STAFF RECOMMENDATION
916 Acklen Avenue
September 16, 2020

Application: New Construction—Infill and Outbuilding
District: Waverly-Belmont Neighborhood Conservation Zoning Overlay
Council District: 07
Base Zoning: R8
Map and Parcel Number: 10509048000
Applicant: Andrew Heideman, Four Square Design Studio
Project Lead: Melissa Baldock, melissa.baldock@nashville.gov

Description of Project: The application is to construct infill and an outbuilding on a vacant lot. **Recommendation Summary:** Staff recommends approval of the project with the following conditions: **1.** The finished floor height be consistent with the finished floor heights of the adjacent historic houses, to be verified by MHZC staff in the field; **2.** The front porch steps be wood or concrete; **3.** Staff approve the masonry samples, all windows and doors, the roof shingle color and texture, and the driveway material prior to purchase and installation; and **4.** The HVAC be located behind the house or on either side, beyond the mid-point of the house. With these conditions, staff finds that the proposed infills meet Section III. of the design guidelines.	**Attachments** **A:** Photographs **B:** Site Plan **C:**

PROPOSED ELEVATIONS - MAIN HOUSE
SCALE: 1/8" = 1'-0"

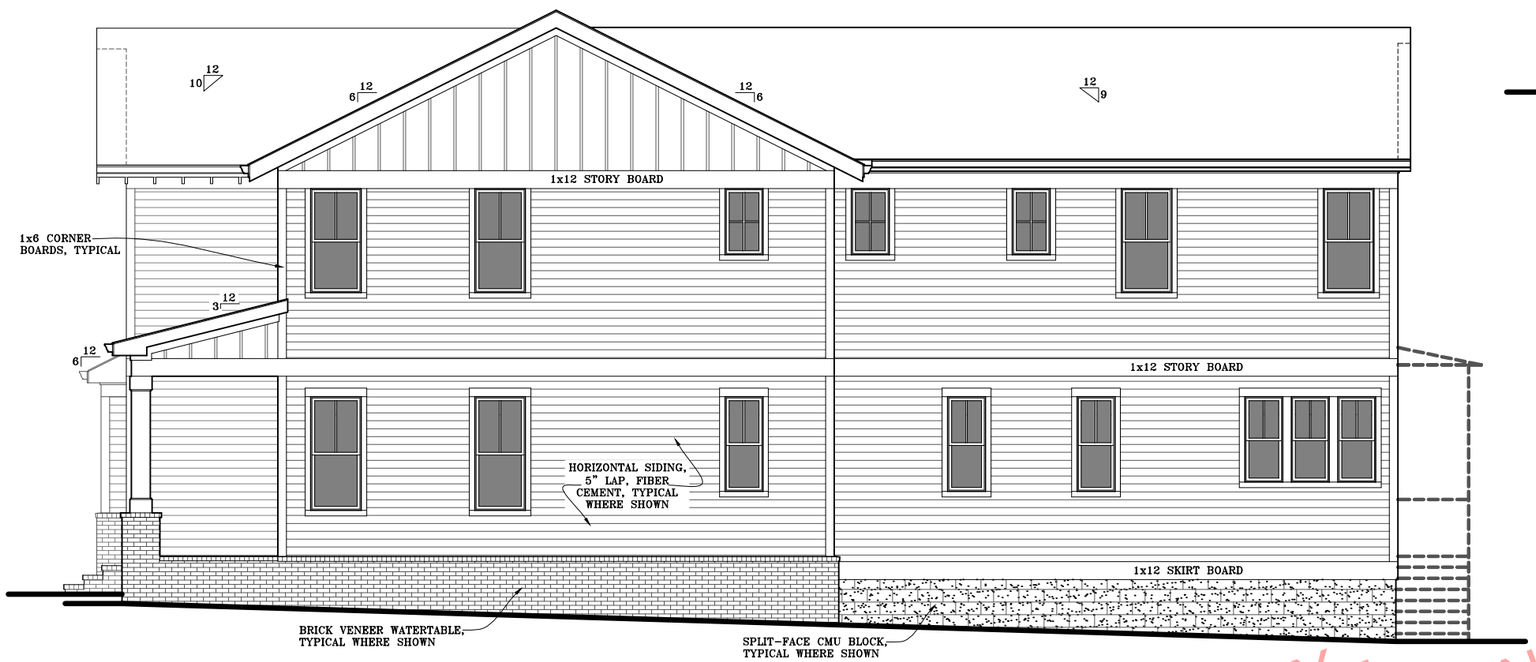
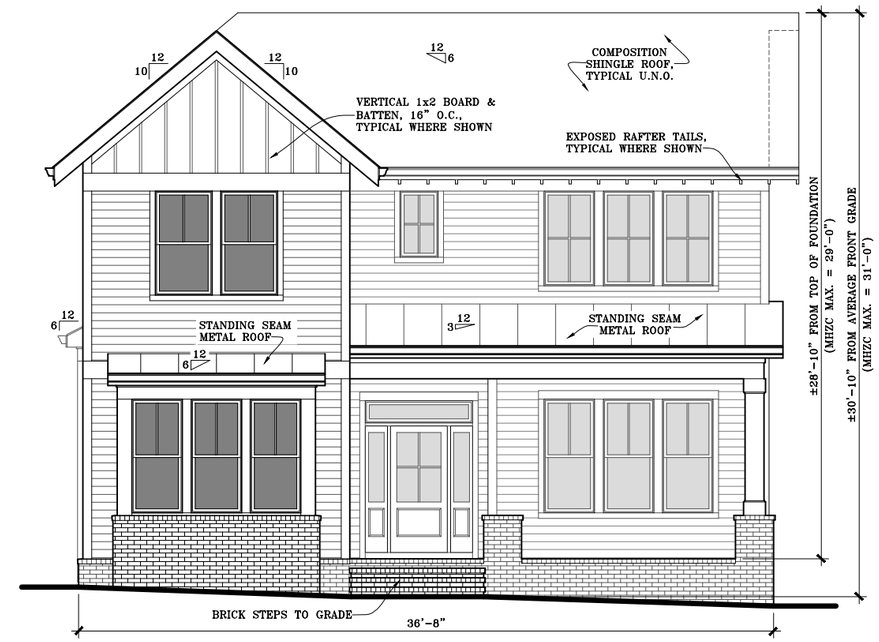
There is a significant cross-slope and front-to-back slope on these lots. The foundation is drawn so that it is as low as possible on the house's left side, but it will be taller on the right side. For lots like this, the foundation and finished floor inspections are critical to ensure that the foundation and finish floor heights match the historic context. Because the site slopes significantly from front to back, the houses gain an extra level at the rear.

The house is thirty-six feet (36') wide, which meets the historic context. Its depth will be approximately seventy-three feet (73'), which staff finds to meet the historic context, particularly since the lot is two hundred and twenty-five (225 ft.) deep. The height of the house will be twenty-eight feet, ten inches (28'10") above the foundation line, which varies due to slope. Staff finds that the overall height and scale are similar to other historic houses in the immediate vicinity and to meet the design guidelines.

Roof form: The house's primary roof form is a cross gable with a 10/12 pitch. Other secondary gables are 6/12 and 9/12. The front porch roof with be a 3/12 shed. Staff finds that these roof forms are similar to other roof forms in the immediate vicinity.

Proportion and Rhythm of Openings**:** The windows on the proposed infill are all generally twice as tall as they are wide, thereby meeting the historic proportions of openings. There are no expanses of wall space without a window or door opening, Staff finds the infills' proportion and rhythm of openings to meet Section III.G. of the design guidelines.

1. The finished floor height be consistent with the finished floor heights of the adjacent historic houses, to be verified by MHZC staff in the field;
2. The front porch steps be wood or concrete;
3. Staff approve the masonry samples, all windows and doors, the roof shingle color and texture, and the driveway material prior to purchase and installation; and
4. The HVAC be located behind the house or on either side, beyond the mid-point of the house.

PROPOSED ELEVATIONS - ACCESSORY GARAGE
SCALE: 1/8" = 1'-0"

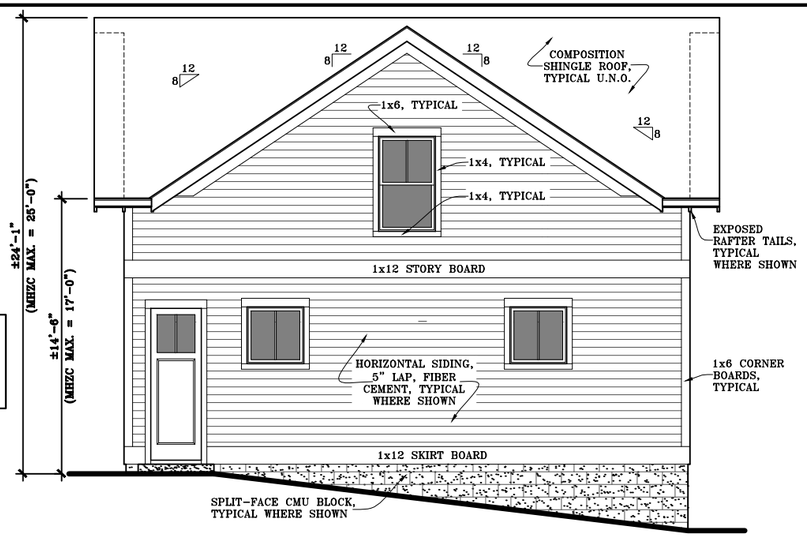
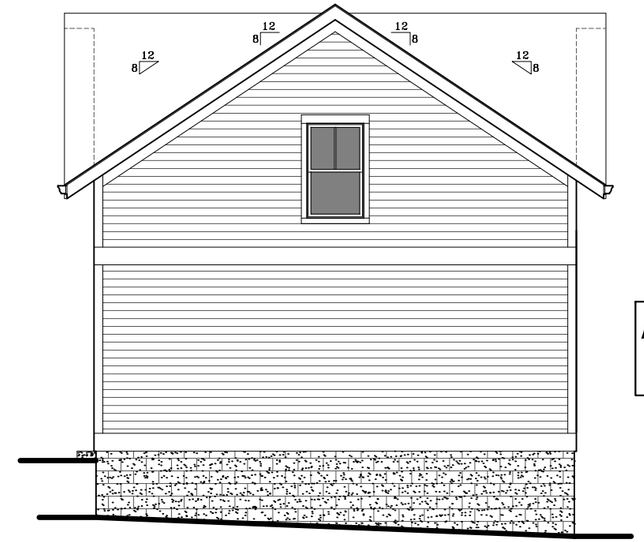
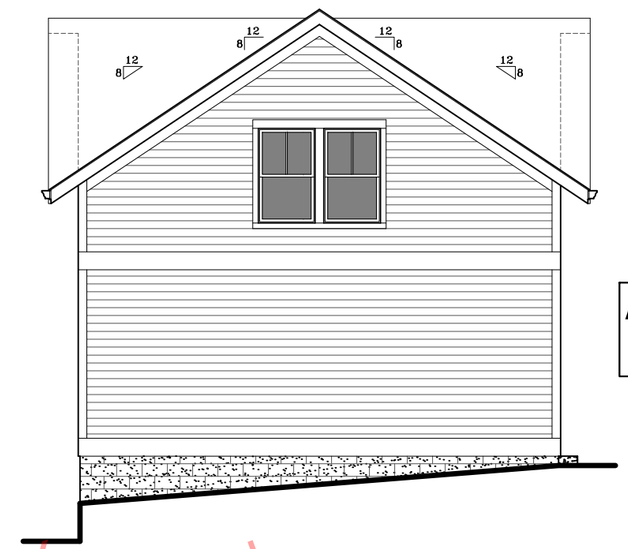
* The outbuilding will have eave and ridge heights that vary from grade because of the extreme slope of the lot. The average eave and ridge heights meet the seventeen foot (17') and twenty-five foot (25') limits of the design guidelines, and staff therefore finds that the outbuilding's height and scale meet the design guidelines.

The roof form does not include any dormers. Staff finds that the outbuilding meets Section III.H.3 of the design guidelines for roof shape.
